Access Compliance Report

Public Rights-of-Way

(Curb Ramps)

Intersection ID: 3143	Main Street: MALLARD_WOODS_PL	Cross Street: LAWRENCE_GRAY_RD	Location: SE
ADA ID: 6AF283AD0C25	Ramp Type: Perp	Initial Pass/Fail: Fail	Overall Compliance: No
Severity Score: 37.5			
Codes/Mitigation Info/Possible Solution		Field Measurements/Component Compliance

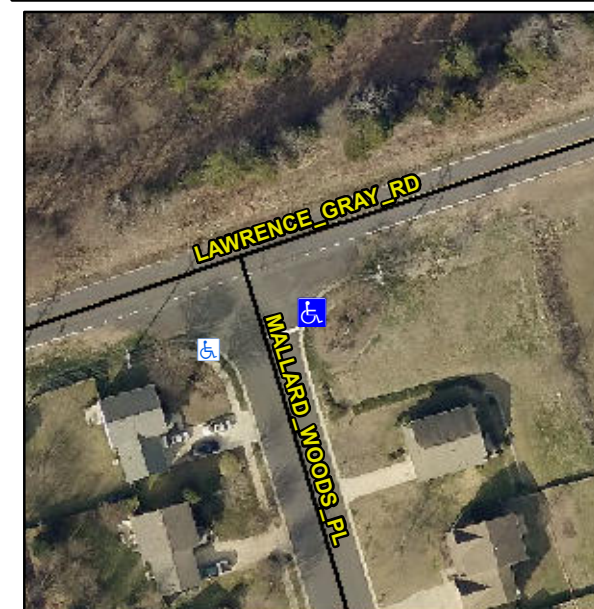
Not Found, R304.2.2, R304.5.3

Compliance	Description	Data	Compliance	Description	Data
N/A	Ramp Length (in)	50.0	No	Ramp Slope (%)	10.3
Yes	Ramp Width (in)	78.0	No	Ramp XSlope (%)	8.7
N/A	Flare Type LT	N/A	N/A	Flare Type RT	N/A
N/A	Flare Slope LT (%)	N/A	N/A	Flare Slope RT (%)	N/A
N/A	Flare Traversable LT?	N/A	N/A	Flare Traversable RT?	N/A
N/A	Landing Length (in)	N/A	N/A	DWS Provided?	N/A
N/A	Landing Width (in)	N/A	N/A	DWS Contrast?	N/A
N/A	Landing Slope (%)	N/A	N/A	DWS Length (in)	N/A
N/A	Landing X Slope (%)	N/A	N/A	DWS Full Width?	N/A
N/A	Landing Curb? (Y/N)	N/A	N/A	DWS Offset (in)	N/A
N/A	Shared Landing?	N/A			
N/A	Gutter Ponding?	N/A	N/A	Gutter Slope (%)	N/A
N/A	Gutter Lip Ht (in)	N/A	N/A	Gutter X Slope (%)	N/A
N/A	Painted X Walk1?	No	N/A	Painted X Walk2?	N/A
	X Walk 1 Direction	To W		X Walk 2 Direction	N/A
N/A	X Walk 1 Width (in)	N/A	N/A	X Walk 2 Width (in)	N/A
	X Walk 1 Slope (%)	2.9		X Walk 2 Slope (%)	N/A
	X Walk 1 X Slope (%)	5.3		X Walk 2 X Slope (%)	N/A

Remove & Replace Entire Ramp.
